Access Compliance Report

Public Rights-of-Way

Intersection ID: 8508	Main Street: W_SUGAR_CREEK_RD	Cross Street: GLORY_ST	Location: SW
ADA ID: B0393C85D4C3	Ramp Type: PerpDiag	Initial Pass/Fail: Pass	Overall Compliance: No
Severity Score: 2.5			
Codes/Mitigation Info/Possible Solution		Field Measurements/Component Compliance

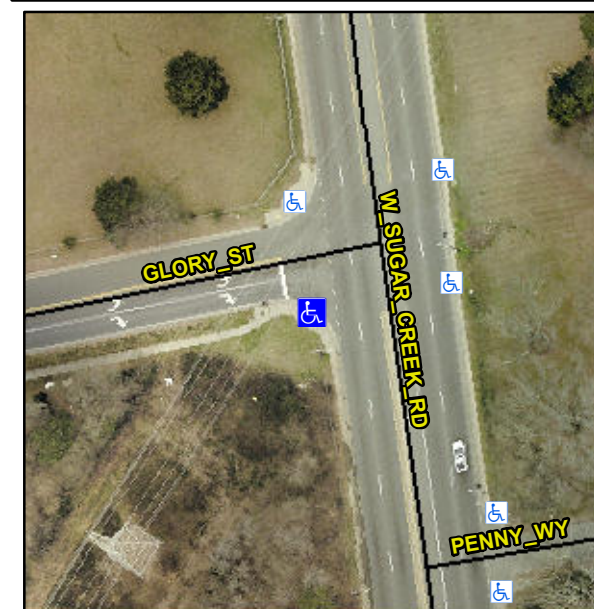
Not Found, R304.2.1, R304.5.3, R304.2.3, R305.2

Compliance	Description	Data	Compliance	Description	Data
N/A	Ramp Length (in)	73.0	Yes	Ramp Slope (%)	7.5
Yes	Ramp Width (in)	48.0	Yes	Ramp XSlope (%)	2.0
N/A	Flare Type LT	Sloped	N/A	Flare Type RT	N/A
N/A	Flare Slope LT (%)	4.8	No	Flare Slope RT (%)	10.4
N/A	Flare Traversable LT?	Yes	N/A	Flare Traversable RT?	Yes
No	Landing Length (in)	47.0	Yes	DWS Provided?	Yes
Yes	Landing Width (in)	48.0	Yes	DWS Contrast?	Yes
Yes	Landing Slope (%)	1.5	Yes	DWS Length (in)	24.0
No	Landing X Slope (%)	3.8	Yes	DWS Full Width?	Yes
N/A	Landing Curb? (Y/N)	No	No	DWS Offset (in)	3.5
N/A	Shared Landing?	No			
Yes	Gutter Ponding?	No	Yes	Gutter Slope (%)	2.0
Yes	Gutter Lip Ht (in)	0.0	No	Gutter X Slope (%)	2.2
N/A	Painted X Walk1?	No	N/A	Painted X Walk2?	No
	X Walk 1 Direction	To E		X Walk 2 Direction	To N
N/A	X Walk 1 Width (in)	N/A	N/A	X Walk 2 Width (in)	N/A
	X Walk 1 Slope (%)	2.5		X Walk 2 Slope (%)	1.4
	X Walk 1 X Slope (%)	1.4		X Walk 2 X Slope (%)	2.8

Remove & Replace Curb Ramp With Two New Directional Ramps or Equivalent. Remove & Replace Gutter.
